ENGINE - DIFFUSER AND COMBUSTOR GROUP - PROVIDE A NEW NO.4 BEARING SUPPORT ASSEMBLY
WITH INCREASED DURABILITY - CATEGORY CODE 5 - MOD.ENG-72-0112

V2500-ENG-72-0112

Location of No.4 bearing support assembly
Fig.1

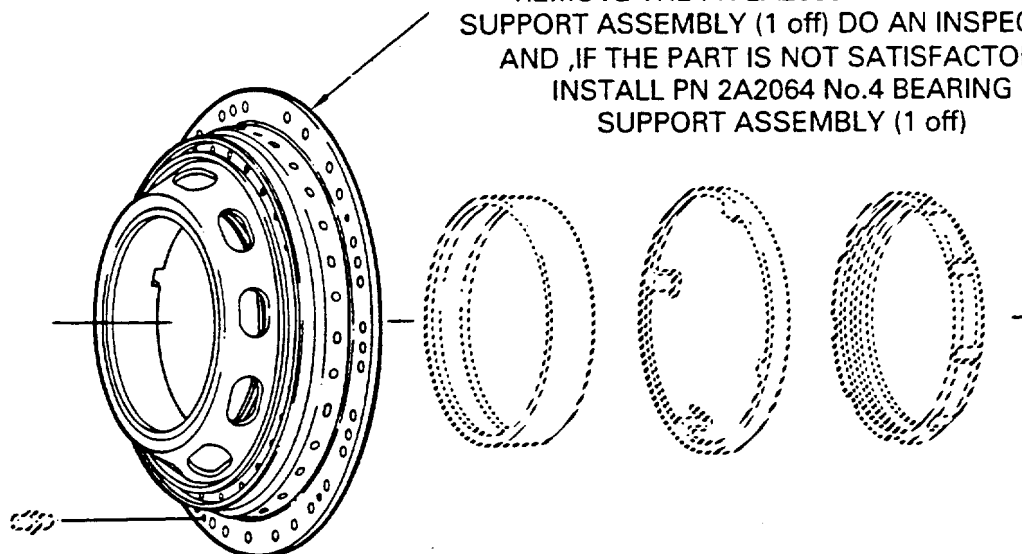
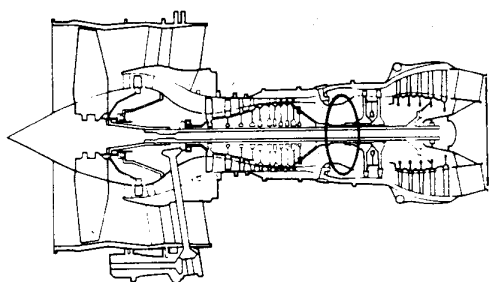
REMOVE THE PN 2A2038 No.4 BEARING
SUPPORT ASSEMBLY (1 off) DO AN
INSPECTION AND IF ACCEPTABLE,IDENTIFY
AND INSTALL AS PN 2A2461 No.4 BEARING
SUPPORT ASSEMBLY (1 off)

REMOVE THE PN 2A2038 NO.4 BEARING
SUPPORT ASSEMBLY (1 off) DO AN INSPECTION
AND ,IF THE PART IS NOT SATISFACTORY,
INSTALL PN 2A2064 No.4 BEARING
SUPPORT ASSEMBLY (1 off)

- (c) If the hardness is less than 40 HRC, replace the 2A2038 No.4 Bearing Support Assembly with a 2A2064 No.4 Bearing Support Assembly. Refer to Figure 1. See paragraph D. Post-requisite Instructions.

Location of No.4 bearing support assembly
Fig.2

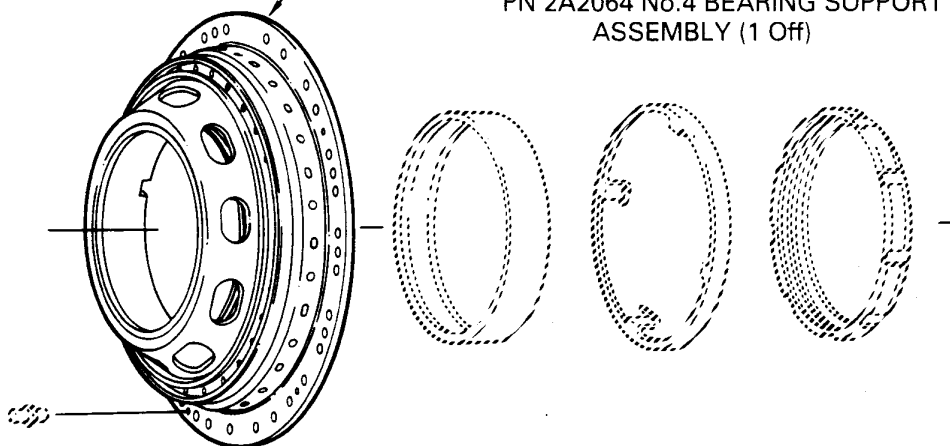
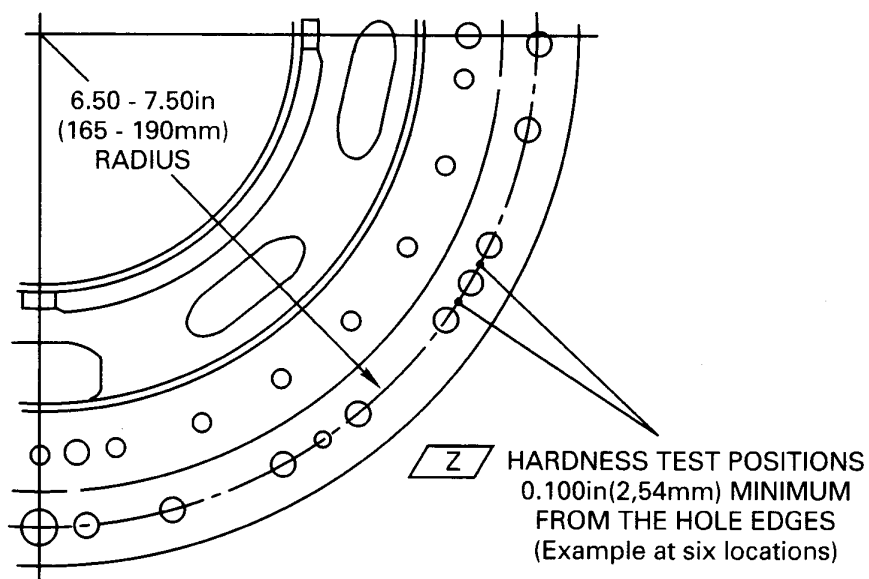
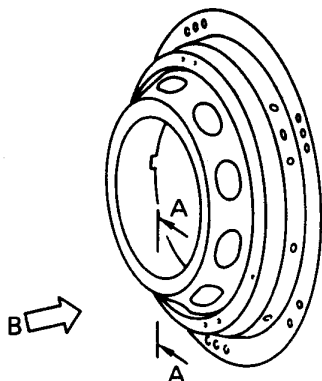
REMOVE THE PN 2A0846 No.4 BEARING
SUPPORT ASSEMBLY (1 Off) DO A
MODIFICATION, IDENTIFY, AND INSTALL
AS PN 2A2461 No. 4 BEARING SUPPORT
ASSEMBLY (1 Off)

REMOVE THE PN 2A0846 No.4 BEARING
SUPPORT ASSEMBLY (1 Off) AND INSTALL
PN 2A2064 No.4 BEARING SUPPORT
ASSEMBLY (1 Off)

(c) Mark the New part Number adjacent to the Old Part Number. Use the vibration peen method.	OLD PART NO.	NEW PART NO.
	2A0846	2A2461
	Refer to Figure 2 and Figure 3, Sheet 2 requirements Refer to Reference (3) Control No./Task No. 70-09-00-400-501.	
Replace the 2A0846 No.4 Bearing Support Assemblies (Reference (1) Fig/Item No. 01-010) with more than 2800 engine cycles. Use a 2A2064 No.4 Bearing Support Assembly. Refer to Figure 2.

No.4 bearing support inspection and identification areas
Fig.3 Sheet 1 of 2

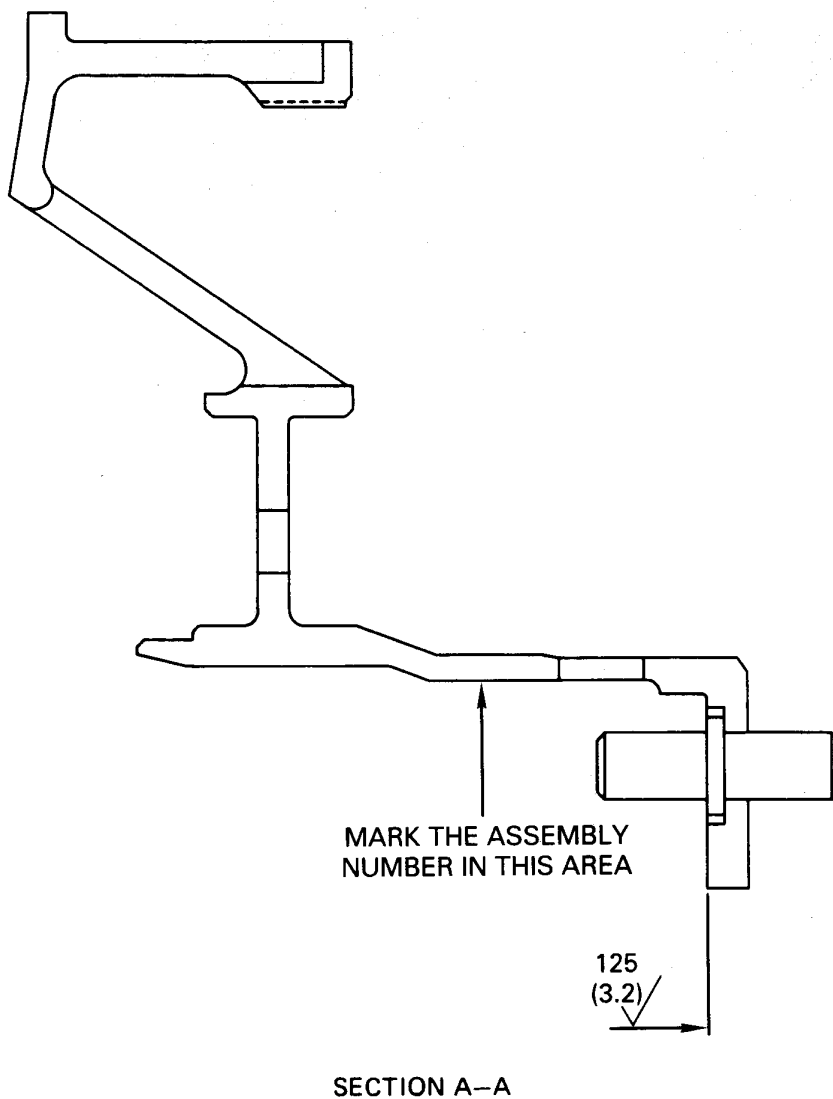
Procedure	Supplementary Information				
<p>(a) Check the Bearing Support for a 40 HRC or equivalent hardness.</p> <p>NOTE: Each location Z has two test points you can use. There are six locations and a total of twelve possible points where you can do the necessary hardness checks. The hardness check must be done at five points.</p>	<p>Refer to Figure 1 and Figure 3 requirements. Do the hardness check on stationary machine that will correctly support the part. Do the hardness test on the radius at any 5 of 12 positions given in Figure 3. Do the test 0.100in. (2,54 mm) from the hole edges.</p>				
<p>(b) If the hardness is 40 HRC or more, mark the New Part Number adjacent to the old part number. Use the vibration peen method.</p>	<table><tr><th>OLD PART NO.</th><th>NEW PART NO.</th></tr><tr><td>2A2038</td><td>2A2461</td></tr></table> <p>Refer to Figures 1, and 3 for requirements and Reference (3), Control No./Task No. 70-09-00-400-501. Remove any high metal caused by the test. Keep the surface finish requirements given in the Figure.</p>	OLD PART NO.	NEW PART NO.	2A2038	2A2461
OLD PART NO.	NEW PART NO.				
2A2038	2A2461

Modification of No.4 bearing support assembly
Fig.4

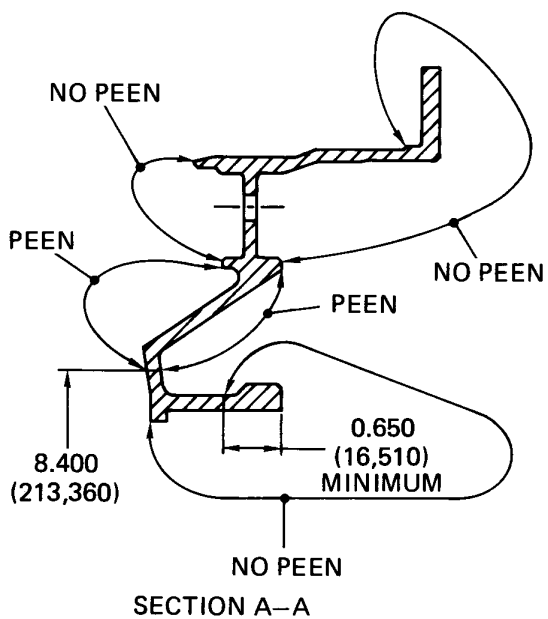
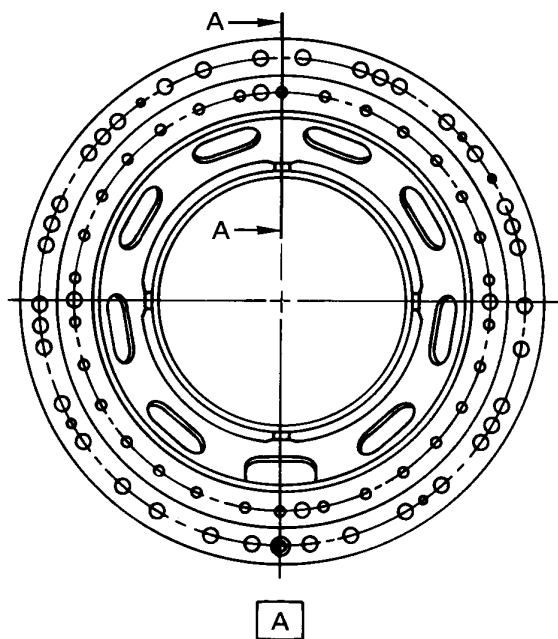
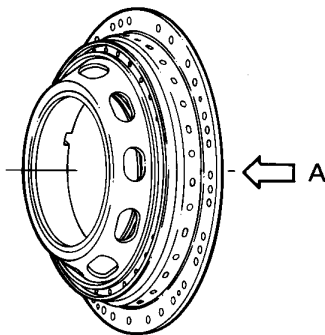
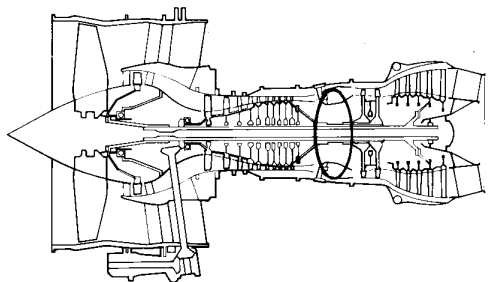
Procedure	Supplementary Information	
(a) Round the edges of all slots in the No. 4 Bearing Support Assembly.	Refer to Figures 2 and 4 requirements.	
(b) Shotpeen the No. 4 Bearing Support Assembly to an intensity of 6A using SAE 170 maximum cast steel shot (Hardness 45-55 HRC or equivalent by TASK 70-38-13-380-501 (AMS 2430)).	Refer to Figures 2 and 5 requirements. Refer to the approved procedure in Reference (3), Chapter/Section 70-38-13 Surface Treating.	
NOTE: Overspray is permitted on all other surfaces if not differently specified.
